**BEST STREAM AND WETLAND RESTORATION PROJECT
MONITORING REPORT
MONITORING YEAR 7
FINAL**

DUPLIN COUNTY, NORTH CAROLINA
CONTRACT No. 004631 - PROJECT No. 95353
USACE Action ID No. 2012-01384 -NCDWR Project No. 13-0865

RE: Best Stream and Wetland Restoration Project: MY7 Monitoring Report (NCDMS ID 95353)

Listed below are comments provided by DMS on January 11, 2022 regarding the Best Stream and Wetland Restoration Project: Year 7 Monitoring Report and RES' responses.

Figure 3c
Best Stream and Wetland Restoration Project
Current Conditions
Plan View
MY7 2021

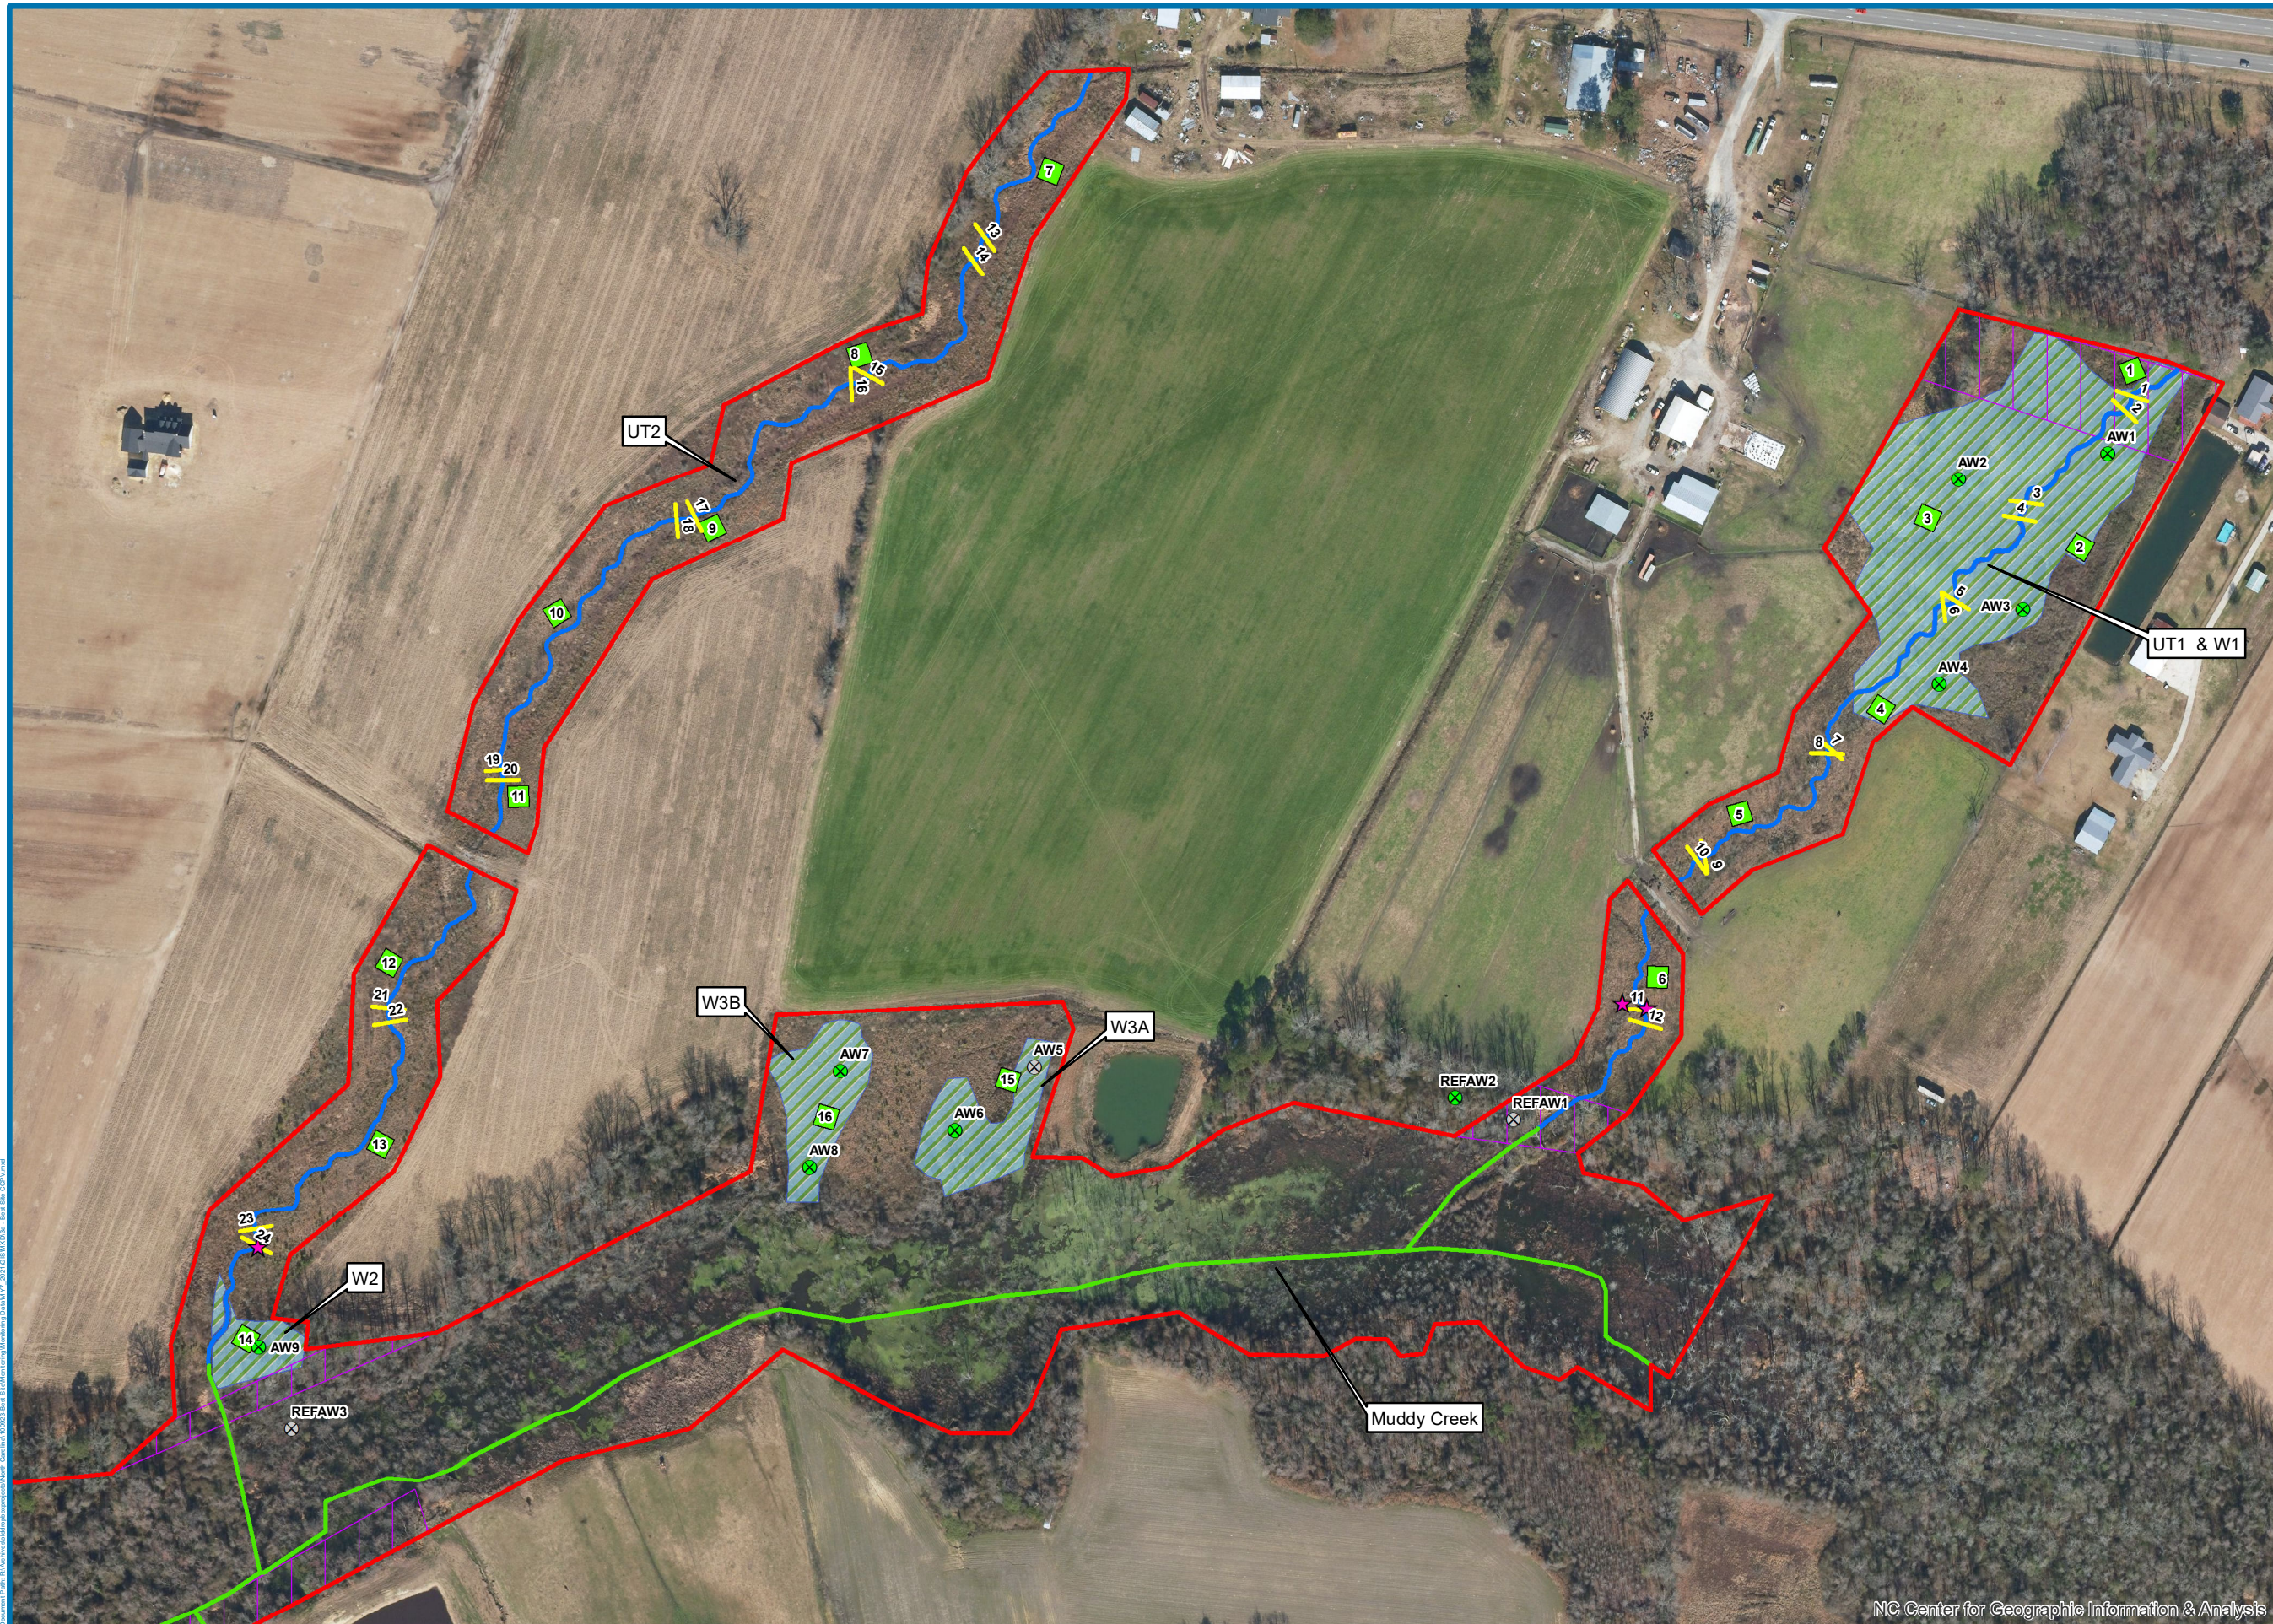
1. Please submit polygons representing the low stem density area and invasive treatment areas and ensure both are displayed in the CCPV and correctly represented in Table 6. [A polygon for MY7 invasive treatment was added to the CCPV. The areas were not added to Table 6 because they are no longer a problem area. Additionally, the area in and around VP18 is not considered a low stem density area because of the survival of the existing trees \(RVP1\) so was not added to the CCPV.](#)
2. Please submit a feature characterizing the random veg plot.
[Done.](#)
3. Please update the groundwater gauge figures to delineate the growing season more clearly. The MY6 figures serve as an example.
[Done.](#)
